Certificate of Appropriateness

Property 3014 W. MC KINLEY BL. Cold Spring Park HD

Date issued 11/5/2021 PTS ID 115215 COA: sidewalk repair and column reconstruction

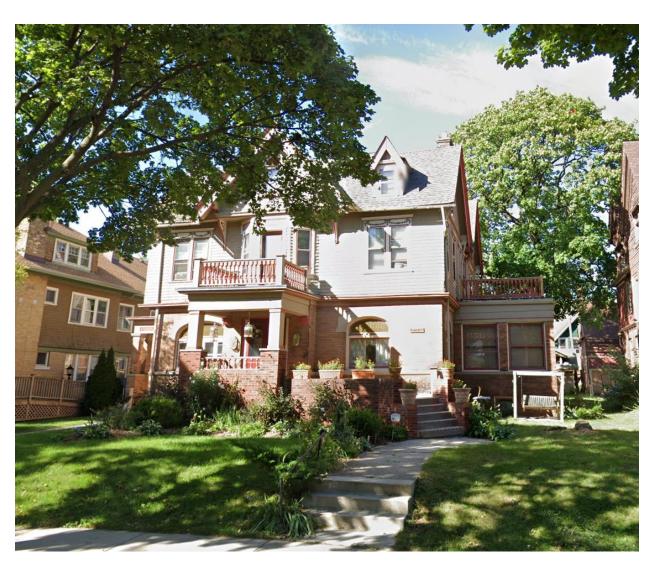
All finish wood must be smooth and free of knots and must be painted or treated with an opaque stain upon completion. Note: when new, bare wood is left exposed to the exterior elements for a period of only a week or two, the life the of the paint job subsequently applied to it will be decreased. The use of a naturally decay-resistant wood species for exterior finish applications is required for porch areas. Using western white pine or Ponderosa pine is "at your own risk" because this wood has no natural decay resistance and can deteriorate in some exterior settings in just a few years.
